PUBLIC MEETING TOWN OF HUDSON, NH **JANUARY 27, 2016**

Breckenridge Estates – 50 Speare Road ZBA Input Only

Staff Report 27 January 2016

SITE: Breckenridge Estates -- 50 Speare Rd. -- Map 186/Lot013 -- ZI# 03-15

Plan Name:	YIELD PLAN MAP 186, LOT 13
Project	BRECKENRIDGE ESTATES SUBDIVISION SPEARE ROAD, HUDSON, NH 03051
Owner of Record:	DOUGLAS S. SANDERSON

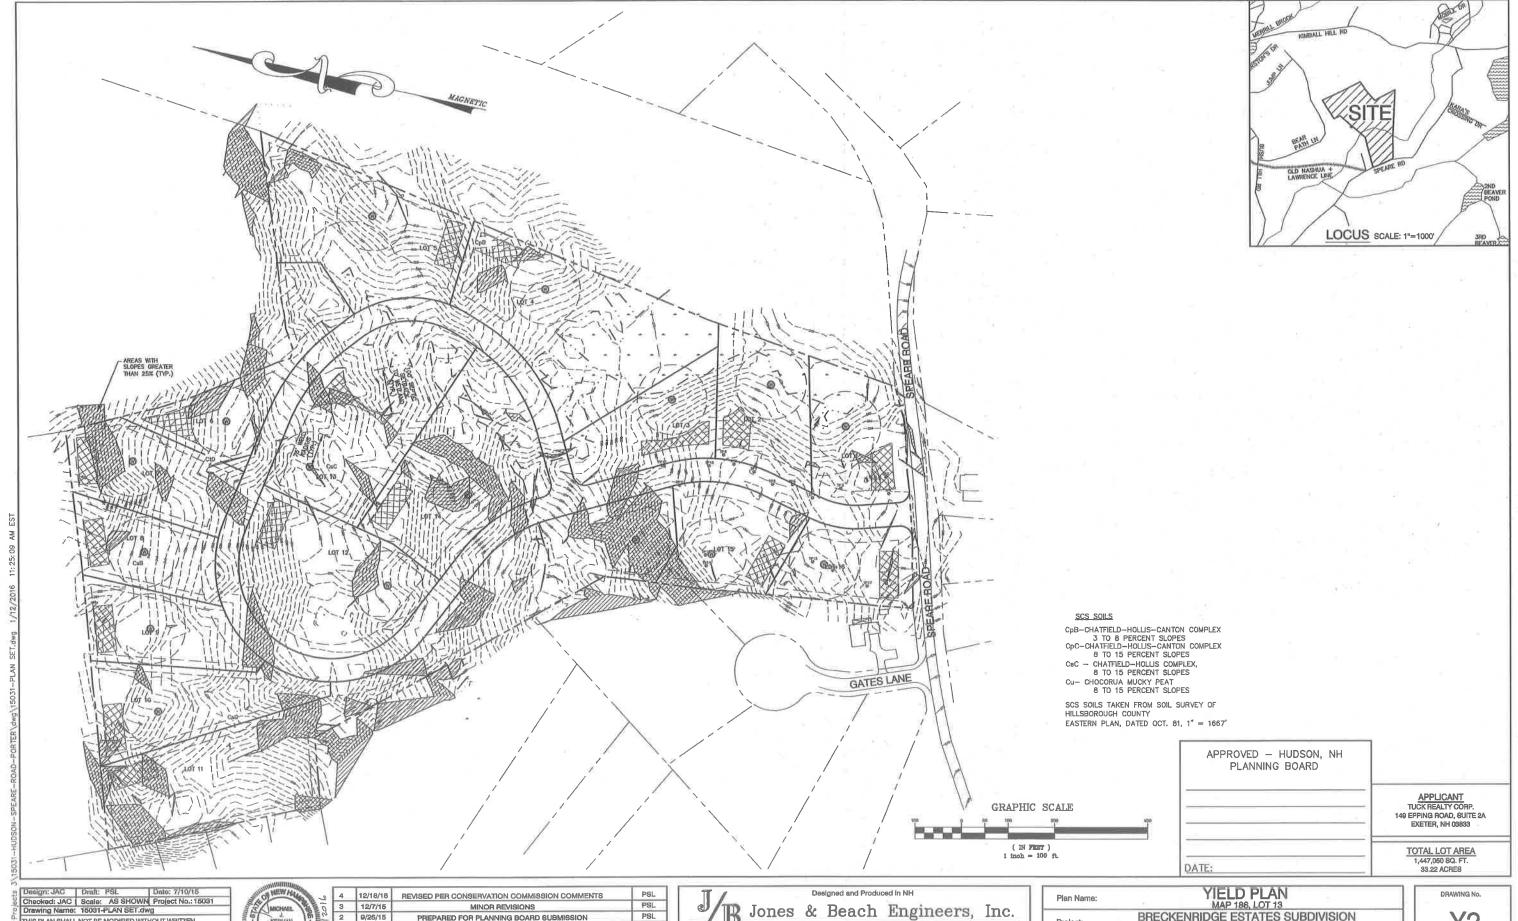
- 2) The Lot Detail Charts found on the Yield Plan (Y1) and Cluster Plan (Conceptual) (C1) show: Gross Lot Area, minus (-) Wetlands, Slopes Greater than 25% (SF) equaling (=) Net Area (i.e., contiguous upland) for each proposed lot. Note: each lot shown meets or exceeds the minimum OSD lot requirements for the subject zoning district (i.e., G, min. OSD lot size = 21,780 sf). Please refer to Article XI Open Space Development of the Zoning Ordinance for all of the OSD provisions. NOTE: although each proposed lot appears to have the minimum required OSD lot frontage of 75 ft., the specific frontage for each lot is not indicated along the front lot line of each lot. Rather, the frontage and other lot line measurements are included in chart form on Sheet A2. For the Definitive OSD Subdivision Plan submission, staff will remind the Applicant to provide the lot line measurements for each lot on at least one Plan sheet.

- 3) The Yield Plans (Y1 & Y2) show a looped road design, which in the past, some board members have considered a means of usurping the 1,000 ft. maximum allowable cul-de-sac length. This issue can be further discussed by board members at the meeting. That is, relative to determining the actual lot yield for this property. On the other hand, the Applicant for this Plan has reduced the Standard Subdivision Lot Yield down from 16 lots to 9 OSD lots. In effect, the Applicant has not maximized the total number of potential lots. The only problem is, as previously cited in above outstanding item #1, the attached plans continue to create too many lots in too small of an area of the development parcel. This issue is more evident, when one reads the comments in Mr. Hebert's attached letter. Wherein, Mr. Hebert cites in the 3d para. of his letter, the following:

SHEET 11 OF 19 JBE PROJECT NO 15031

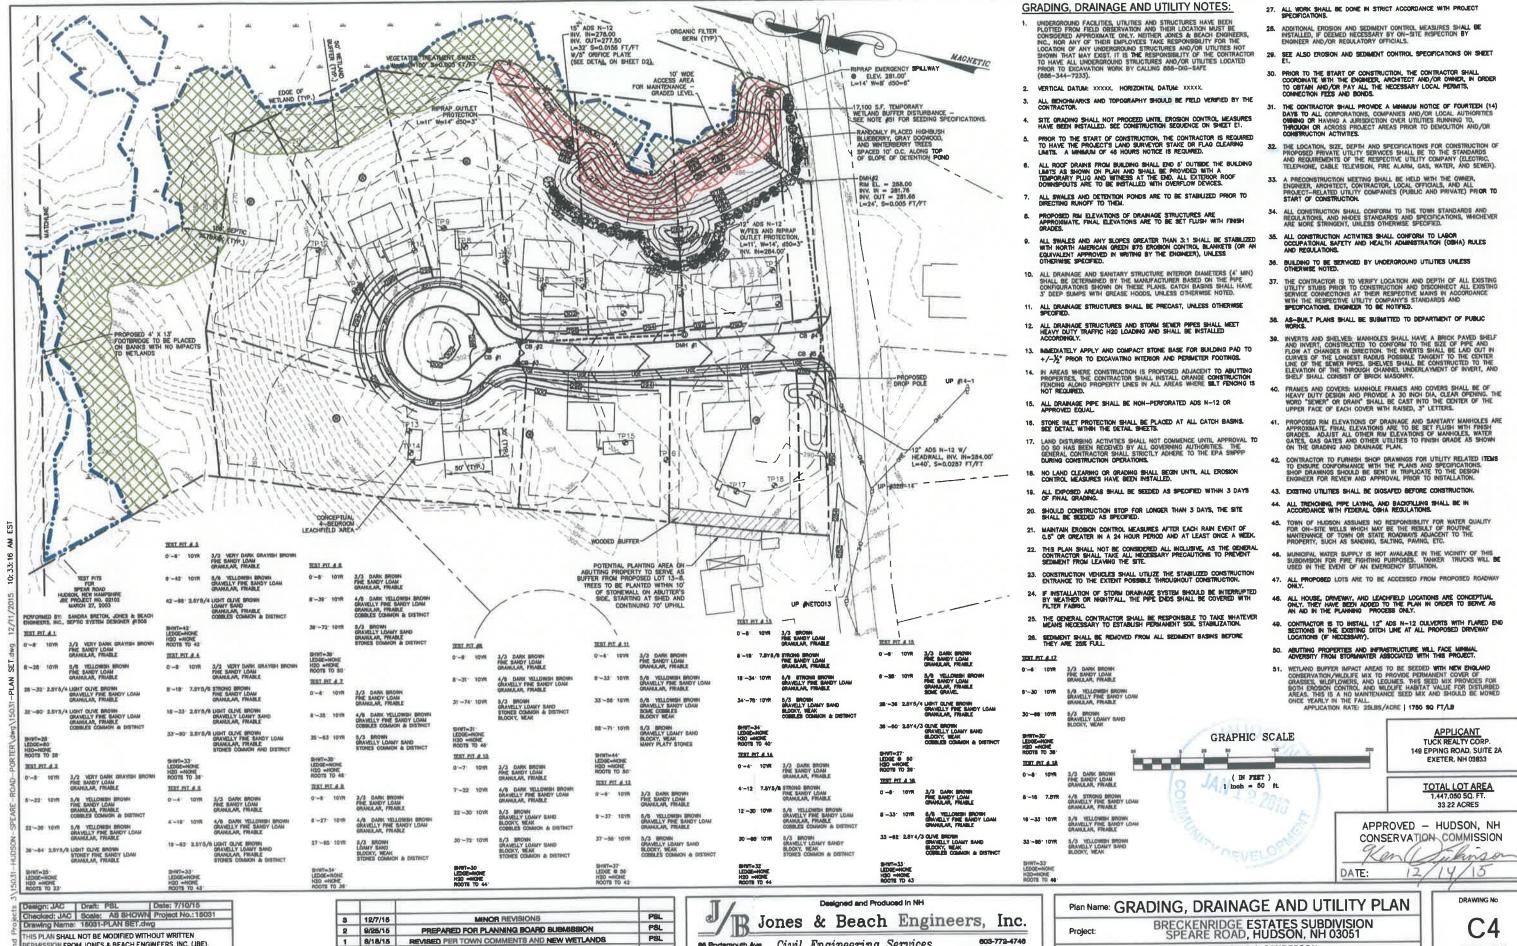
- 7) In accordance with the attached Conservation Commission's "Motion to Recommend a Wetlands Special Exception", please note that the attached Plan set, specifically, Sheet C4, still refers to the "permanent" wetland buffer impact as "temporary". This discrepancy does not comply with Condition #5 of said attachment.

Note: this Sub-section is referred, herein, because of the multiple well protective radii encroachments included in this proposed development. In this regard, please refer to Sheet C4 of the Plan, which depicts said encroachments for all of the proposed lots. In turn, such encroachments are considered noncompliant with cited Sub-section C., which requires the Applicant to either amend the plan accordingly (i.e., create lots not having such encroachments) or provide Town water and sewer to the development parcel.
